Attachment 1 - PLN17/0857 - 19 Howard Street Richmond - Advertising S52 - Plans\_Part1

**Proposed Office Building**  
Altel Holdings  
19 Howard Street, RICHMOND

**To:** Chris Stathis  
**From:** Artemis Bacani  
**Date:** 22 January 2018  
**Subject:** **Application No:** PLN17/0857  
**Description:** Office Development  
**Site Address:** 19 Howard Street, Richmond

TO: Chris Stathis (Statutory Planning)  
FROM: Amruta Pandhe (Urban Design)  
DATE: 25 January 2018  
SUBJECT: 19 Howard Street Richmond  
APPLICATION NO: PLN17/0857  
DESCRIPTION: Development of the land for a four storey (plus rooftop terrace) office building and an associated reduction in the car parking requirement.

Proposed View From Howard Street

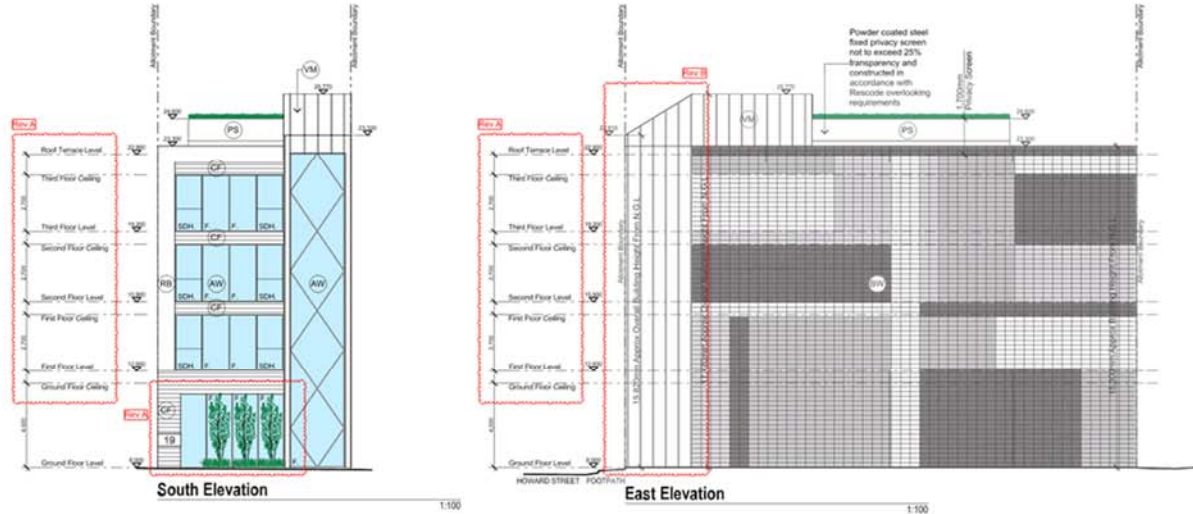
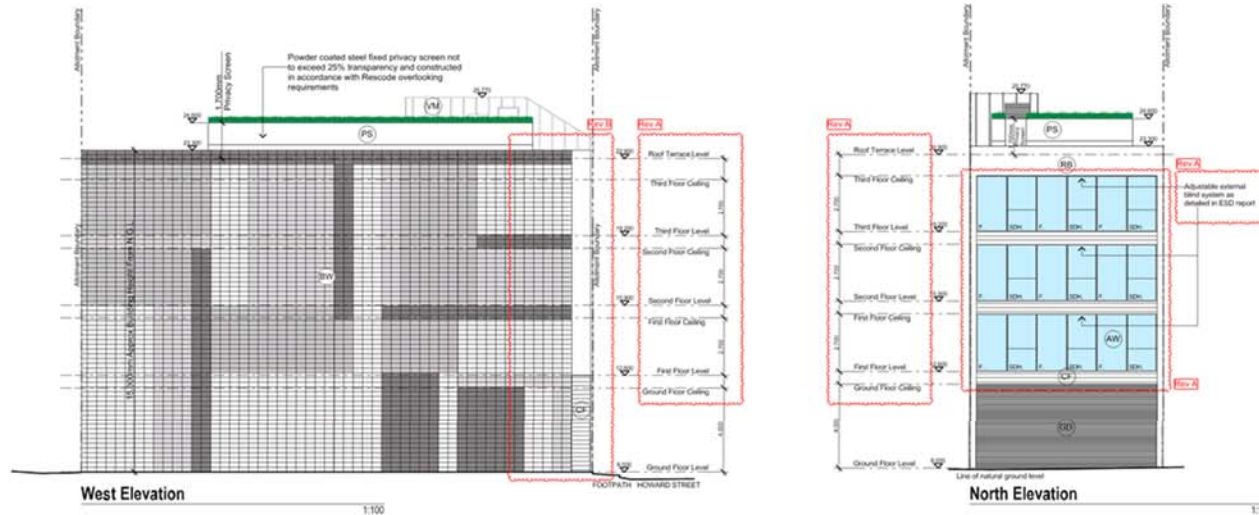
- The ground floor interface is supported.
- The proposed design currently does not present a high quality three-dimensional form, particularly the way the building wraps around the corners. The black render frame and zinc wall cladding for the stairwell are not supported as they draw too much attention and negatively impacts the coherence of the architecture. It is recommended to use lighter colours and architectural treatments that will have visual impact and consideration needs to be given to three-dimensional look of the building.

Given the abutting properties are single storey dwellings the proposed development will be highly visible from all sides until these properties are developed. Hence, the architecture of the building should present a visually interesting form without drawing too much attention to itself. The proposed design currently does not present a high quality three-dimensional form, particularly the way building wraps around both the corners. The abutting residential properties are set back at the ground level, hence consideration should be given to the corners of the buildings at ground floor level as well. The black render framing the building creates too much contrast when viewed from west and detracts from the coherence of the overall architectural composition. Similarly, the colour and material of stairwell area connecting to the roof top terrace is too contrast to the lower levels and draws too much attention to the top level. Hence, it is recommended to use architectural treatments and lighter colours that will have less visual impact and gives consideration to three-dimensional building design.
